Application for Licence Amendment

Licence Number	L8308/2008/3
Licence Holder	CITIC Pacific Mining Management Pty Ltd
ACN	119 578 371
File Number	APP-0028662
Premises	<p>Sino Iron Project Mine Site</p> <p>Mining tenements M08/123, M08/124, M08/125, M08/264, M08/265, M08/266, G08/53, G08/54 and L08/126</p> <p>MARDIE WA 6714</p> <p>As defined by the Premises map attached to the Revised Licence</p>
Date of Report	10 July 2025 (FINAL)
Decision	Revised licence granted

Figure 1: Conceptual design for the decant return and perimeter tailings pipelines

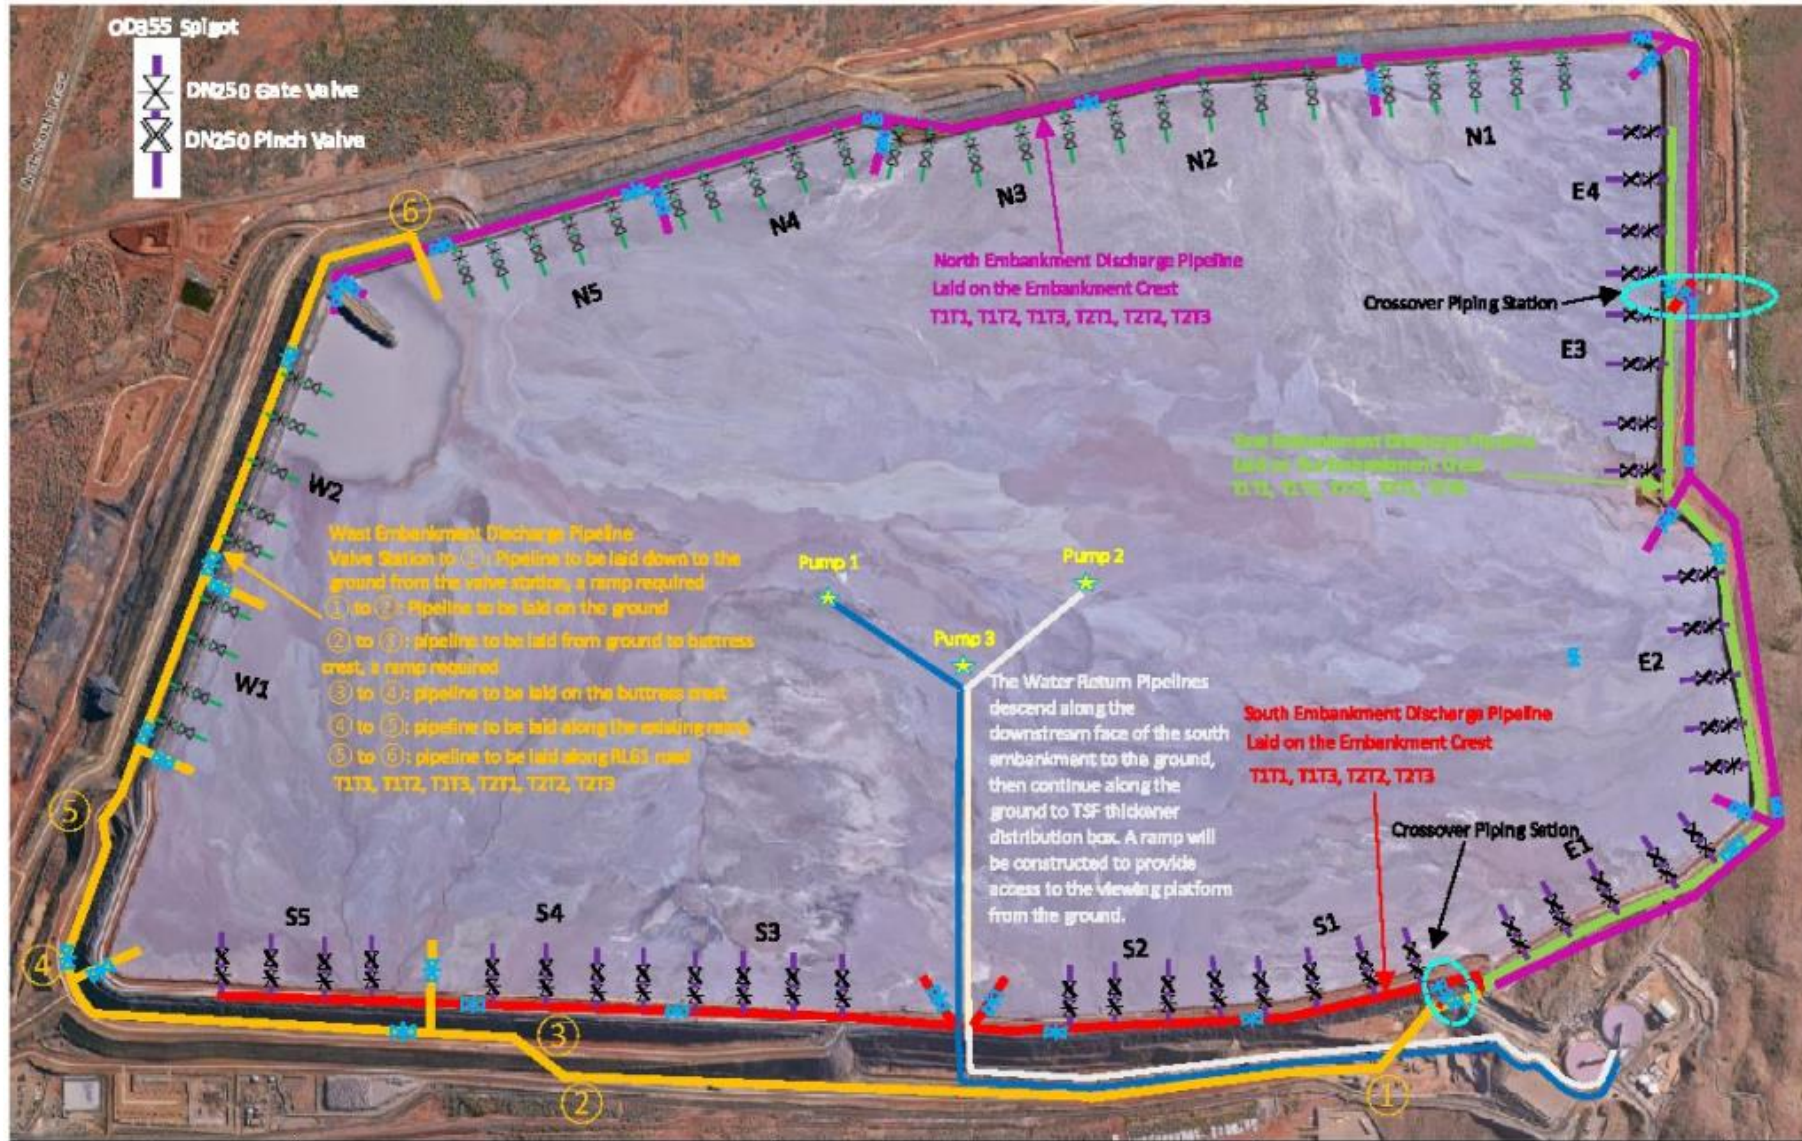
The Licence Holder is proposing to change the tailings deposition methodology from the southern and eastern embankment of TSF2 to instead allow the discharge of tailings from all four sides of the perimeter embankment.

Additional tailings distribution pipelines and spigots will be installed along the northern and western embankment as shown in Figure 1. There are 16 discharge groups distributed across

the four high density polyethylene (HDPE) pipelines, each consisting of three to four discharge spigots. The nominal distance between every two adjacent spigot is 100 m.

Figure 2: Deposition model outputs

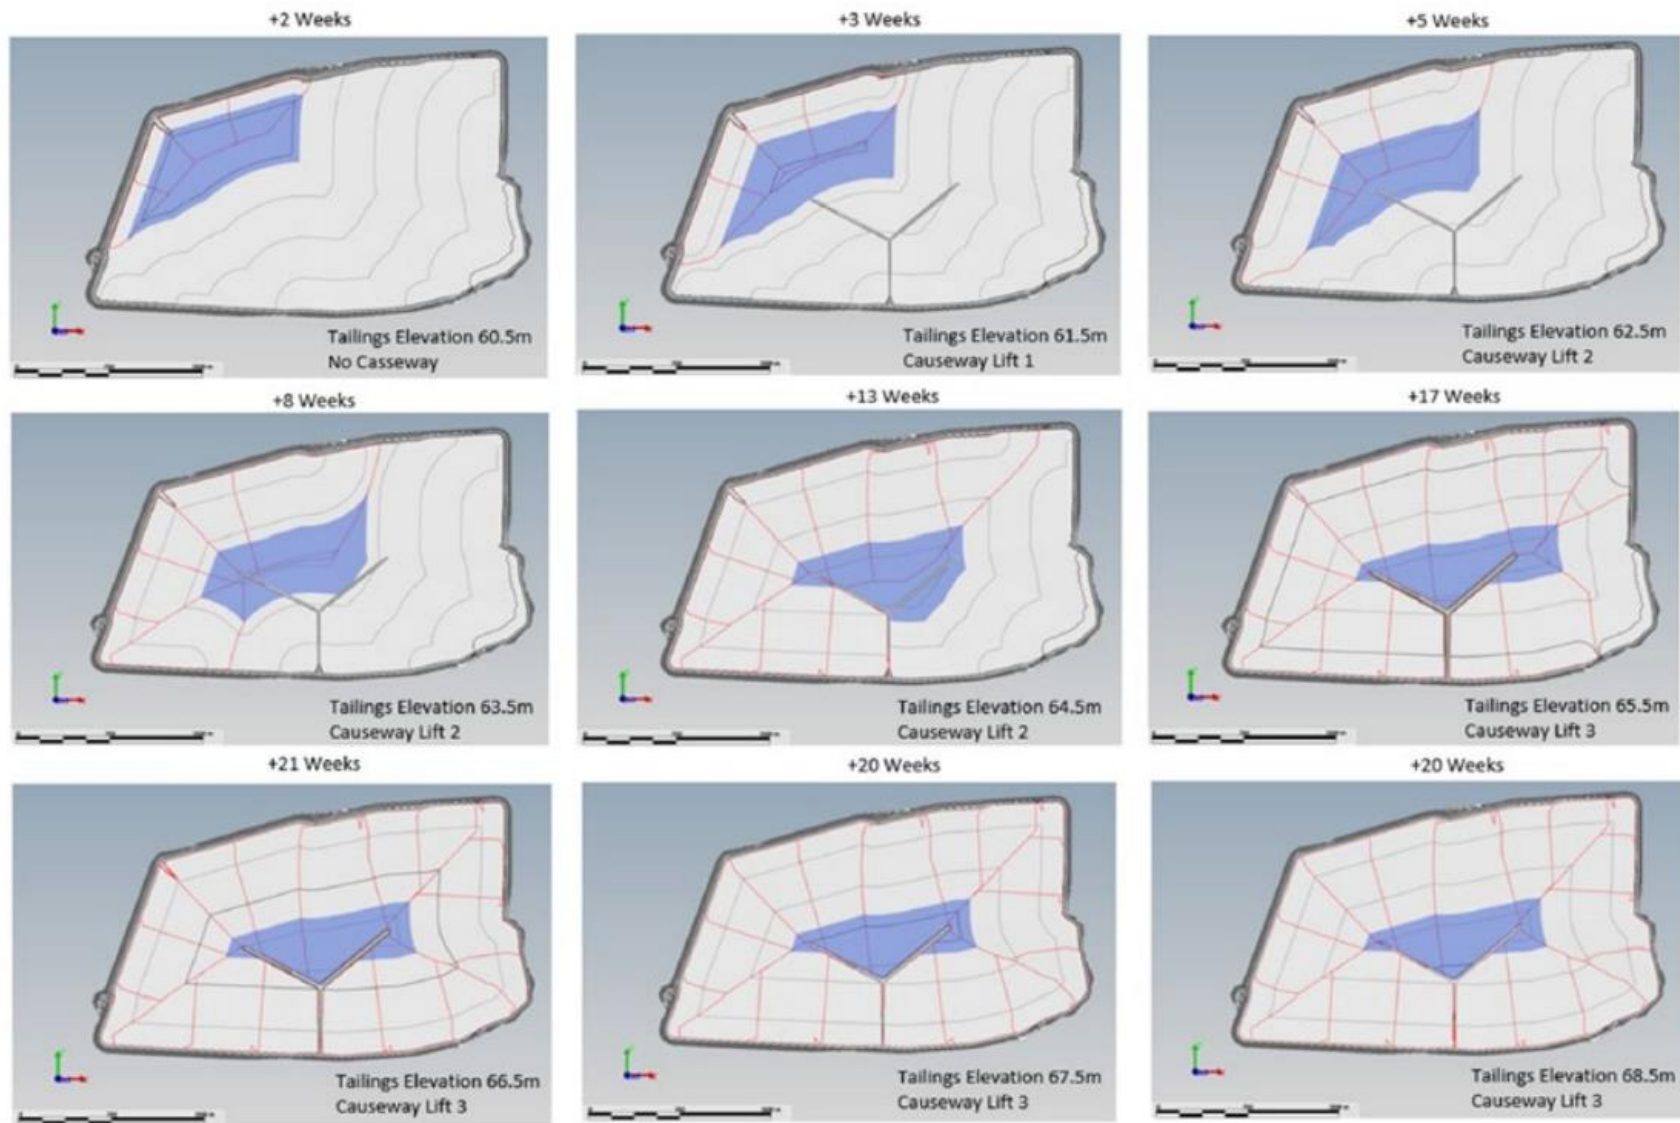
Tailings deposition modelling (using 3D modelling software Muk3D) with consideration of the causeway construction sequencing, was carried out based on the target tailings elevation from 60.5 m to 68.5 m with 1 m increments for each run. This involved a total of 9 steps as shown in Figure 2.

CPM 2025 states the proposed changes to the tailings deposition will not require an increase to the approved tailings deposition volume or change the tailings characteristics (solids density and particle size distribution). Therefore, no material change to the TSF operational water balance is anticipated, and seepage recovery systems remain unchanged.

Figure 3: Causeway layout

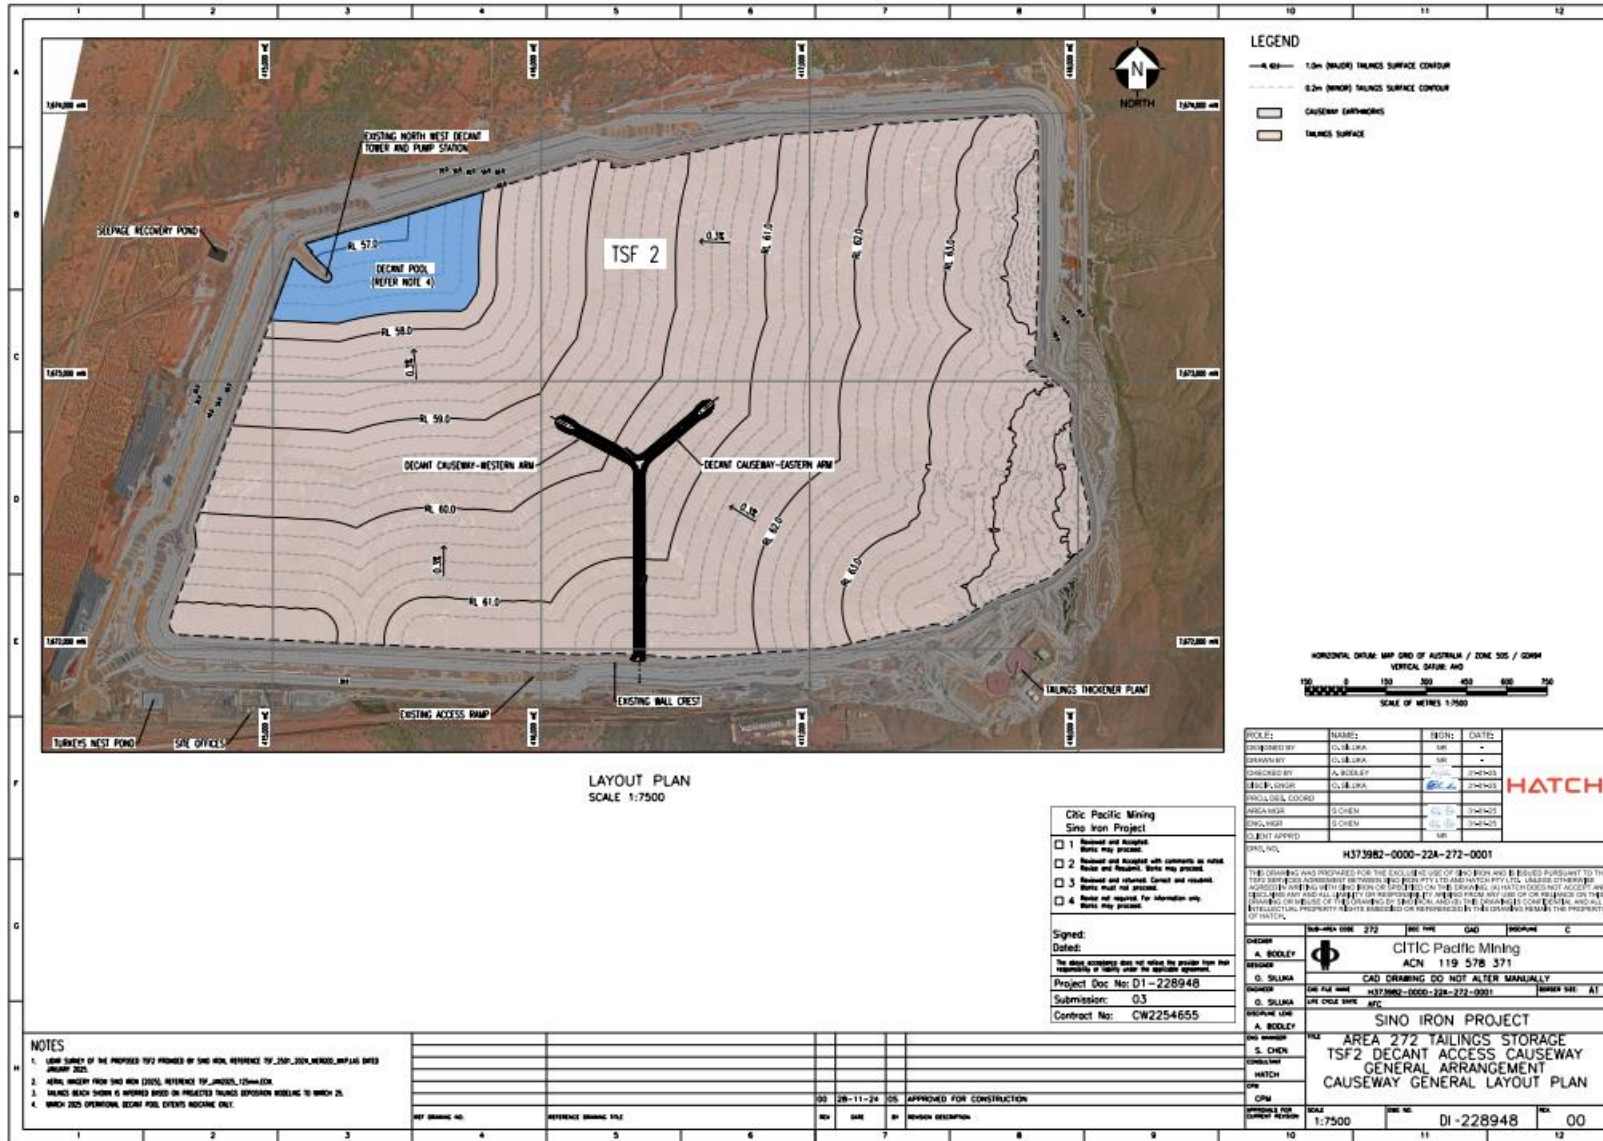
In order to effectively manage the water recovery from the central decant location, a Y-type causeway structure is proposed. The causeway will be extended from the TSF southern embankment wall as shown in Figure 3. The Y-type causeway will facilitate collection of decant water from the centre of the decant ponds by using three floating decant systems (one for each of the two arms and one standby).

The causeway is planned to be constructed in 6 raises. For all raises, a two-stage construction approach is intended to ensure a minimum Factor of Safety of 1.5 based on the assumed tailings strength profile. Overall construction is approximately 22 weeks, with intermittent causeway construction works and tailings deposition which will enable ongoing operations.

The total fill required for the causeways is estimated to be 1.74 million cubic metres (Mm³), comprising 1.69 Mm³ of Type C3 rockfill and 0.05 Mm³ of basecourse material.
